1. COA-072896-2020

2400 Venable Street

STAFF REPORT

Rehabilitate an existing mixed-use building including partial demolition and construction of a front and rear addition.

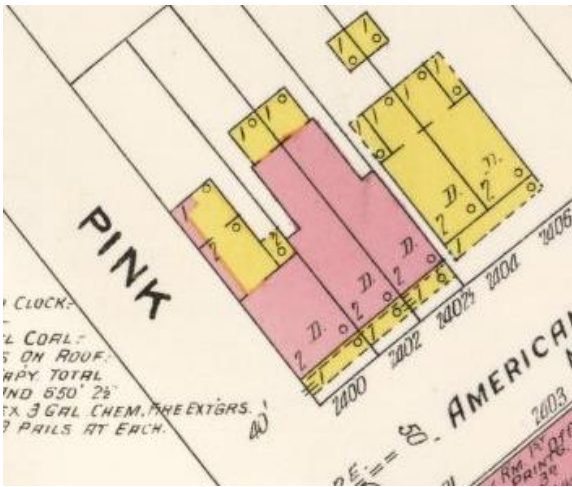
The plans indicate that a glass door will be installed in the front entrance. The plans do not appear to reflect the existing masonry opening, which has been infilled with wood paneling to accommodate a standard door. Staff recommends the new door fit within the existing masonry opening, utilizing sidelights and a transom if necessary, and specifications for the proposed door be submitted for administrative approval.

- The plans be revised to accurately show the fenestration pattern and design prior to the issuance of a building permit.
- The new first story front door fit within the existing masonry opening, utilizing sidelights and a transom if necessary, and specifications for the proposed door be submitted for administrative approval.
